Hi-Fi Products
Service Bulletin

Model: CDP-510/910/505ESD

No. 25

Subject: Intermittent No Eject

Note: Diagram shown is for the CDP-510.

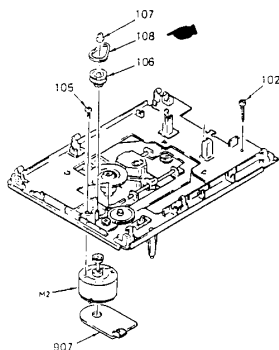
Loading tray is intermittently not ejected.

Solution: Replace the driving belt with the new one as shown:
